Pursuant to Section 2.1043 Siklu herein submits application for Class II Permissive Change in Siklu's V-band Wireless Ethernet Link:

Original FCC Identifier: 2ACYESK-60GTDD-A1 Date of original approval: October 9<sup>th</sup>, 2014

The changes done in the equipment (Hardware revision C0) is the replacement of the RF PCB, with a new RF PCB that is electrically equivalent with the previous RF board. The board is having:

## 1.1 Peak output power test in original Application FCC ID:2ACYESK-60GTDD-A1

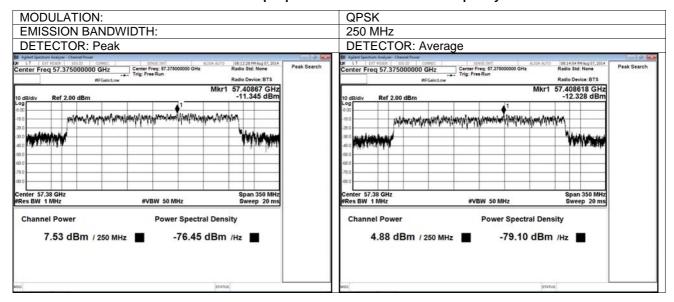
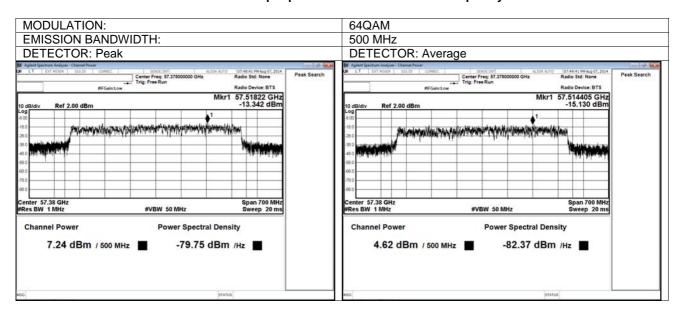
While you will find some differences in the measured results of the output spectrum, these differences are resulting from changes in the test setup settings, as requested by the FCC. The original measurements where done with average detector using RBW of 1 MHz, while the new measurements where done according to FCC guidance with RBW of 8 MHz. These will of course show a higher power, as the integration is done over a larger bandwidth. Yet, the characteristics of the transmitted spectrum are exactly identical, as evident from measurements done with the RBW settings identical to those in the original filing. Measurements for the system after the change with the same settings in the original filings are attached to this letter, showing identical results to the original measurements.
